Letter H: Lisa Cottle, Winston & Strawn for Horizon West Transmission, LLC (February 22, 2021)

Re: Comments of Horizon West Transmission, LLC on the Draft Environmental Impact Report for the Estrella Substation and Paso Robles Area Reinforcement Project, December 2020 (California State Clearinghouse No. 2018072071)

Figure 2. Preliminary Plan

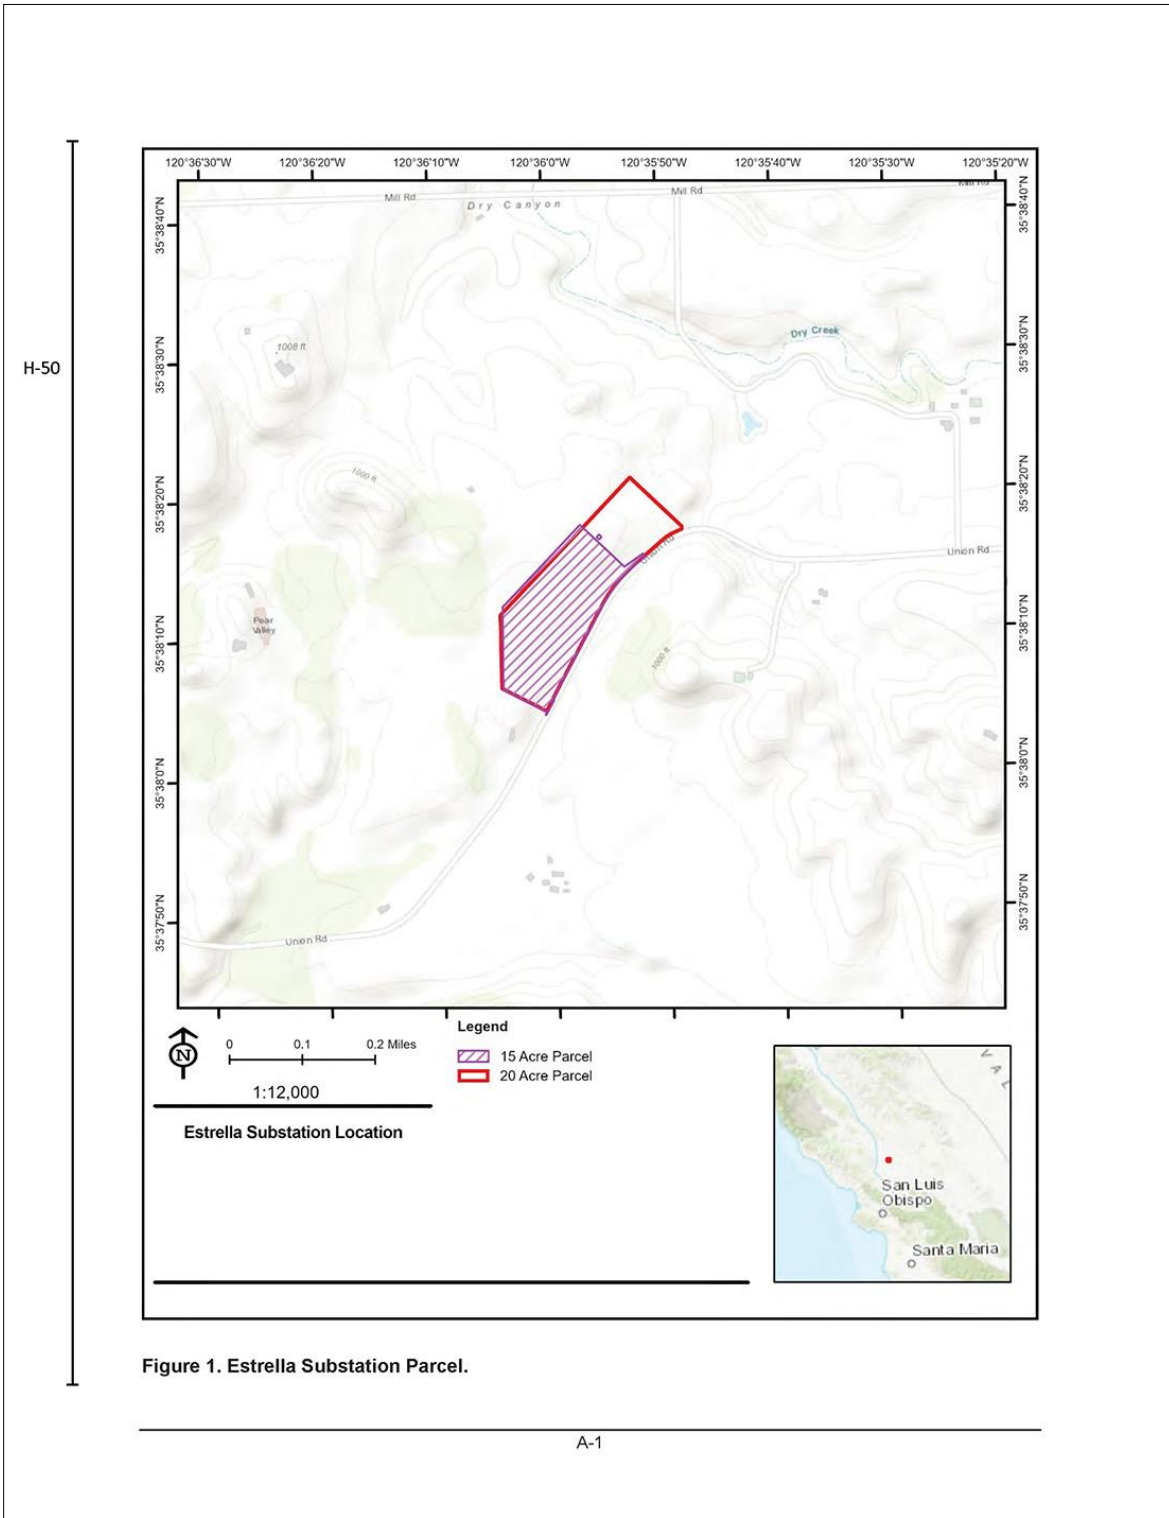
At its closest point, the fence line will be located approximately 64 feet northwest of Union Road, as shown in Figure 2 in **Attachment 1** hereto. Without this change, the design would preclude access to the five-acre addition to the site. This slight reorientation will require approximately 72,000 cubic yards of cut and fill, which will be balanced on site to the extent feasible. The MPR will only result in a slight reconfiguration of the yard equipment and will not affect the type of electrical equipment to be housed within the site's fence line as originally proposed.

The MPR would slightly reorient the 230 kilovolt (kV) and 70 kV yards and associated equipment closer to Union Road to allow access to the additional five acres of land in the northeast portion of the parcel. At its closest point, the fence line for the 230 kV and 70 kV yards would be located approximately 64 feet northwest of Union Road. The configuration of the electrical equipment for the 230 kV and 70 kV substations is provided in Figure 2. The slight reorientation of the substation facilities would require approximately 68,000 cubic yards of cut and fill, which would be balanced on site to the extent feasible. The MPR would extend construction activities at the substation site by one week. The MPR would only result in a sight reconfiguration of the yard equipment and would not affect the type of electrical equipment to be housed within the substation fence line, as originally proposed.
